City of Portsmouth Planning Board

Property Address: 806 Route 1 Bypass

Application #: LU 22-81

806 US Route 1 Bypass
Project Description

TITLE
**EXISTING
CONDITIONS
PLAN**
806 US-1 BYP.
PORTSMOUTH, NH 03801
TAX MAP 161, LOT 43

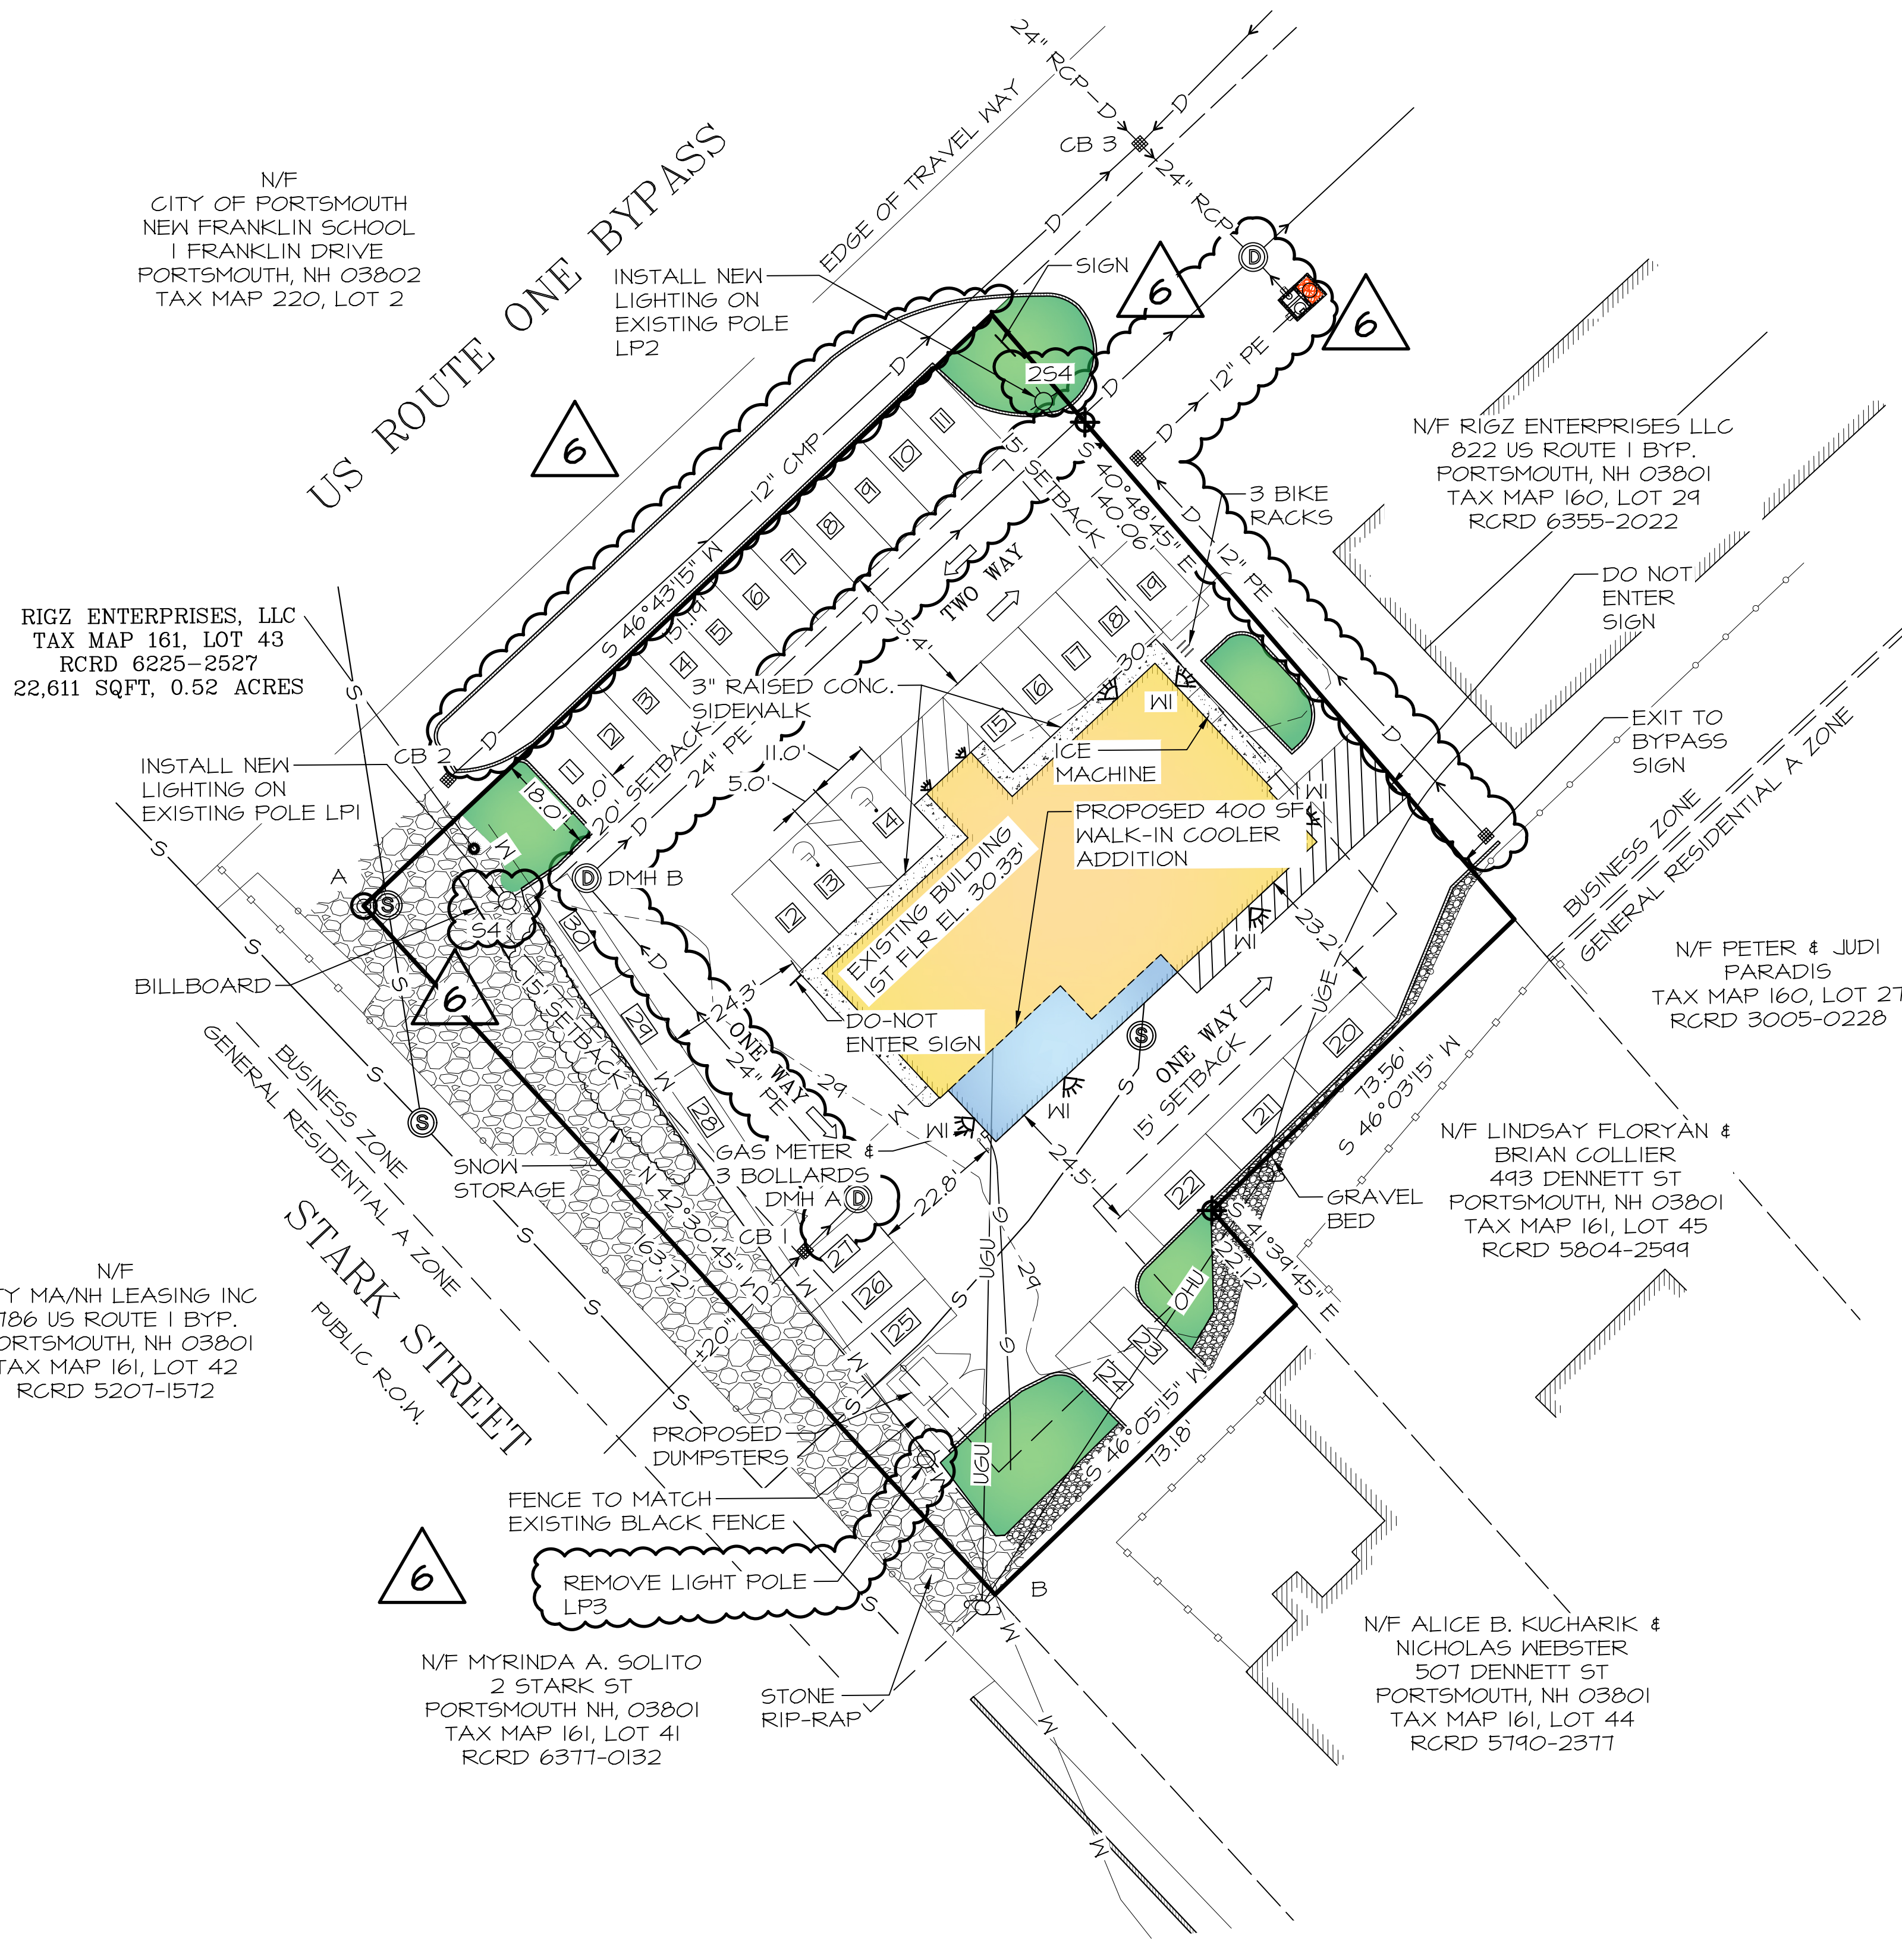
Drawing 1 – Existing Conditions Plan

- Revised existing catch basin elevations
- Added note 6 outlining PB approval and extension of approval.

- REVISED CATCH BASIN ELEVATIONS
- ADDED NOTE 6 TO OUTLINE PB APPROVAL AND EXTENSION OF THIS PROJECT.

TITLE
SITE PLAN

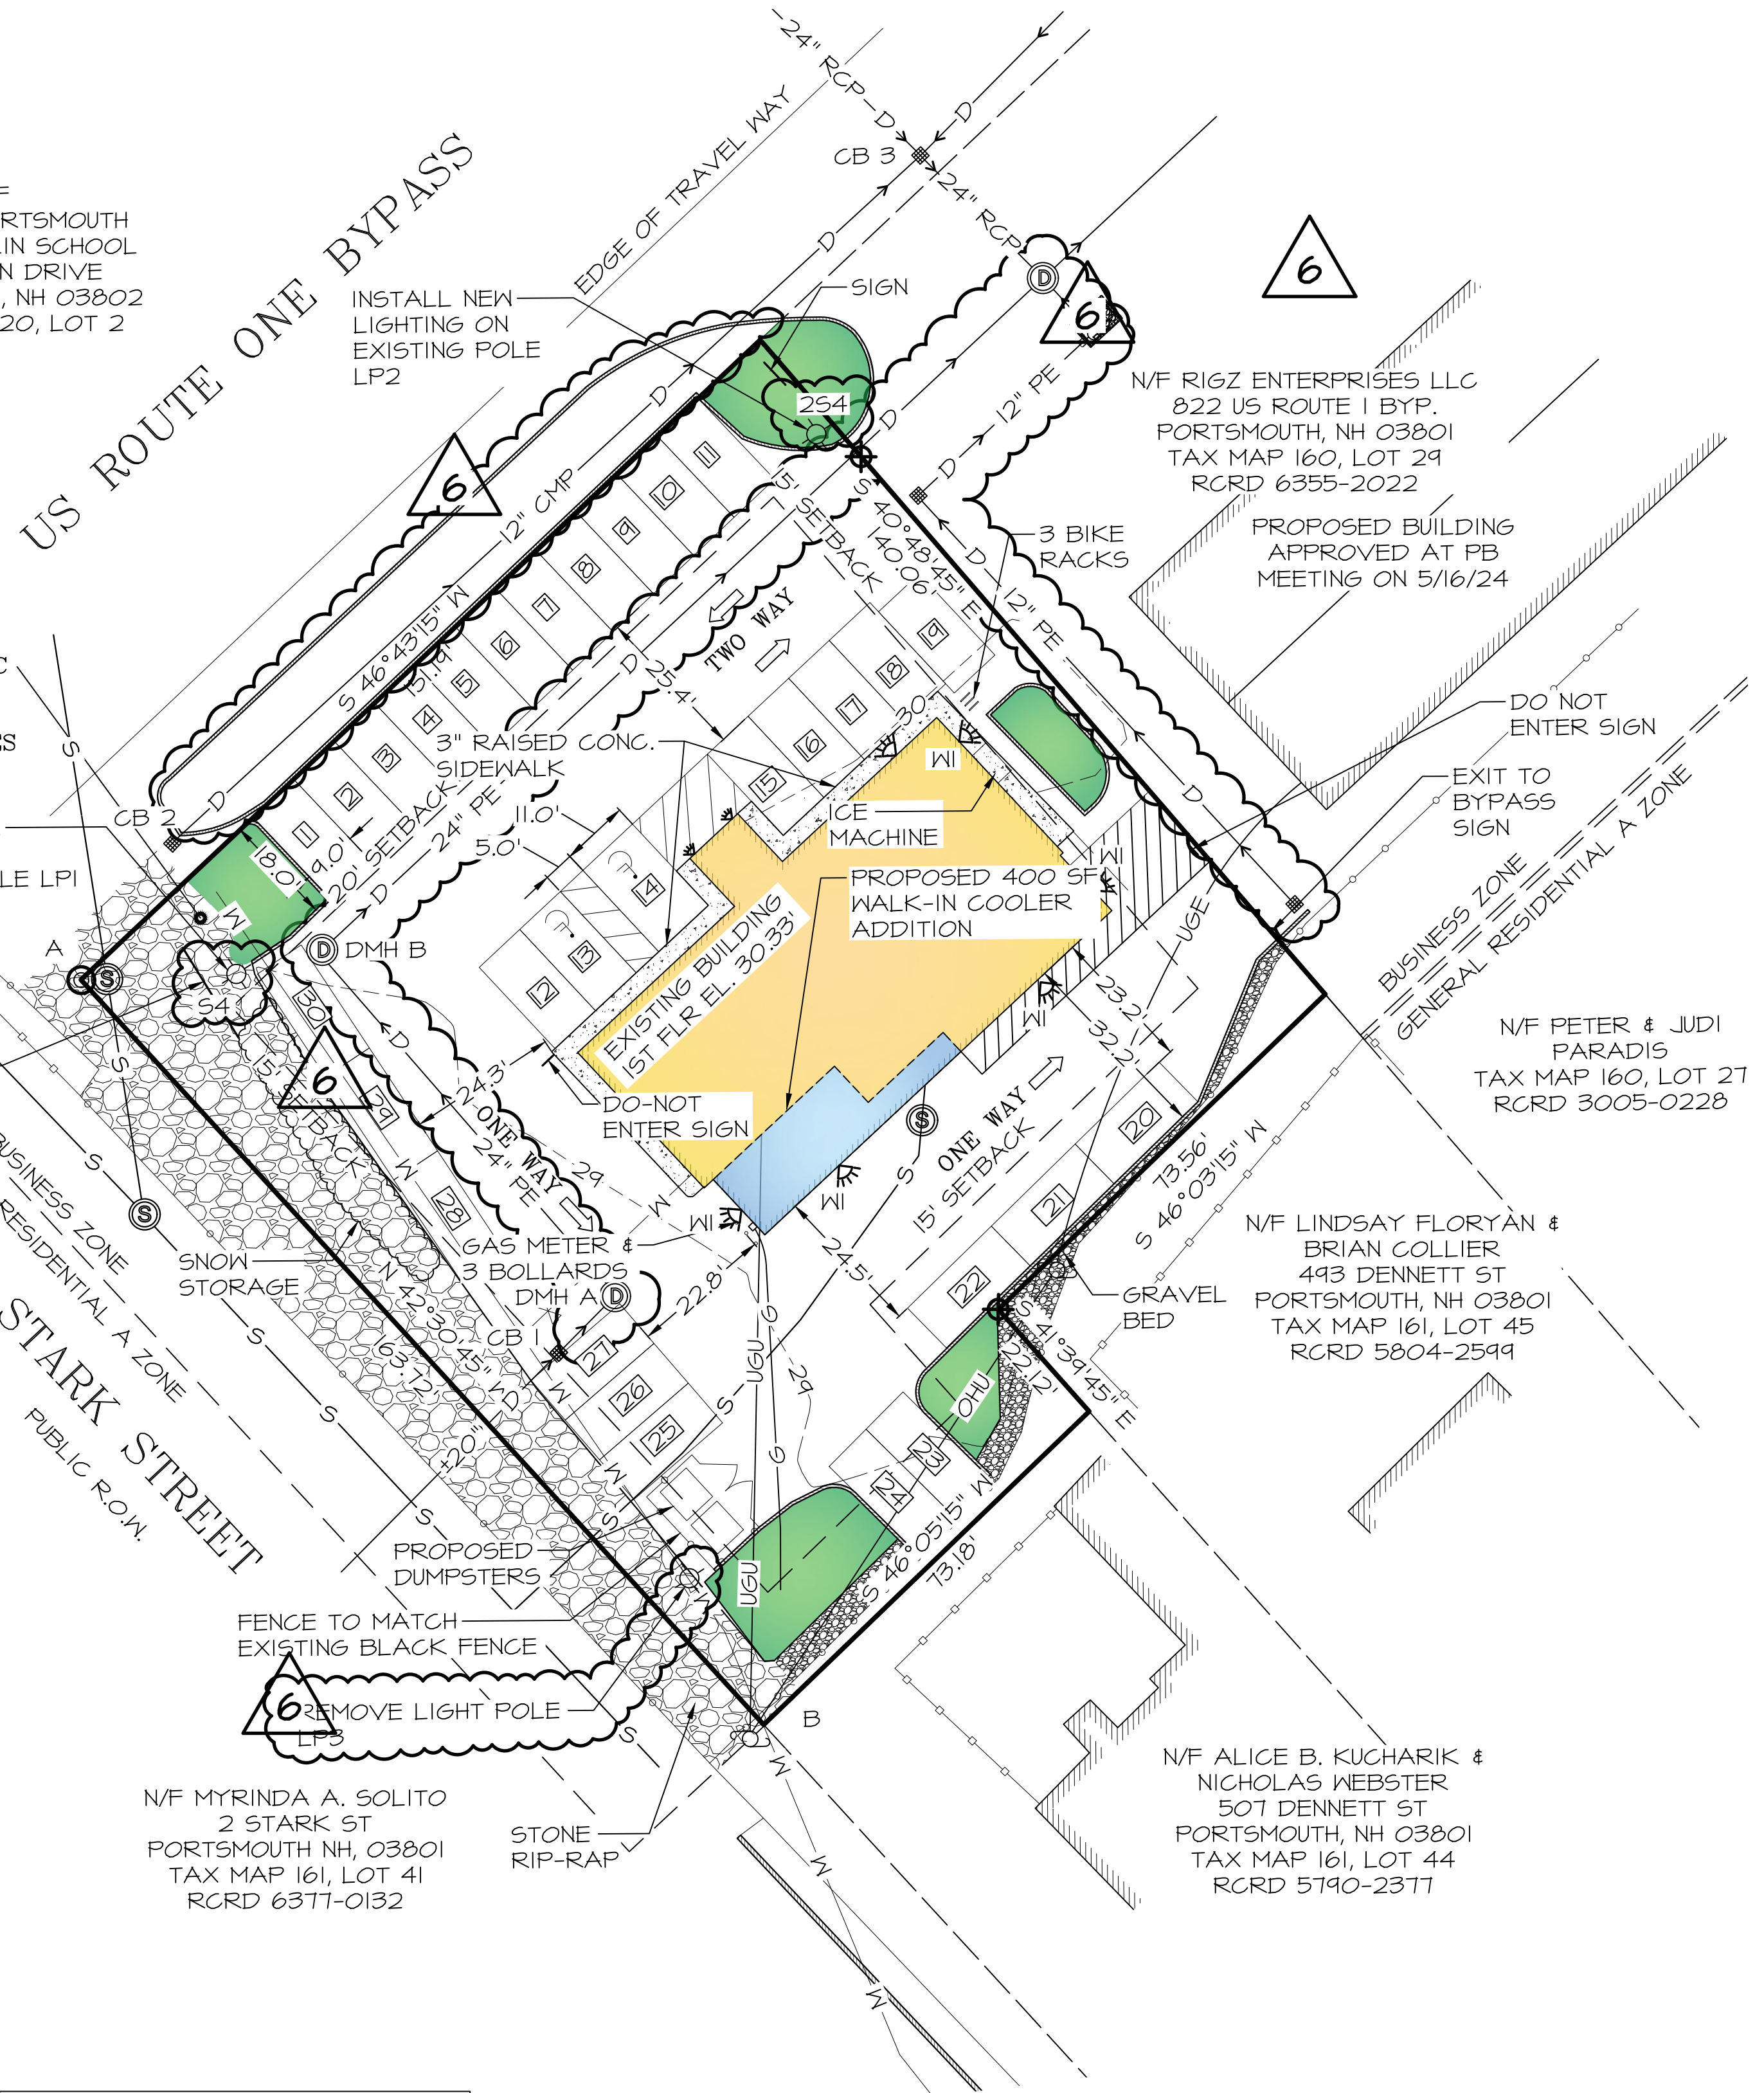
Drawing 2 – Site Plan

- Landscaping removed in NHDOT right of way, as per NHDOT request. This is shown on drawings 2-4.
- Drainage has been changed to depict new proposed drainage system. New drainage system is depicted to match proposed drainage on lot 29, which is connected to drainage system on lot 43. This is shown on drawings 2 & 3.
- Revised lighting callouts on the plan.

- LANDSCAPING REMOVED IN NHDOT RIGHT OF WAY AS PER NHDOT REQUEST.
- DRAINAGE HAS BEEN CHANGED TO DEPICT NEW PROPOSED DRAINAGE SYSTEM. NEW DRAINAGE SYSTEM IS DEPICTED TO MATCH PROPOSED DRAINAGE ON LOT 29, WHICH IS CONNECTED TO DRAINAGE SYSTEM ON LOT 43.
- REVISED LIGHTING CALLOUTS ON THE PLAN.

- 1. Show how you intend to resolve the doctrine of merger issues for drainage and access.*

Note 9 has been added to drawing 2 “Site Plan” stating that all drainage and access easements on both 806 and 822 US Route 1 Bypass shall work in conjunction with each other and will be properly recorded.
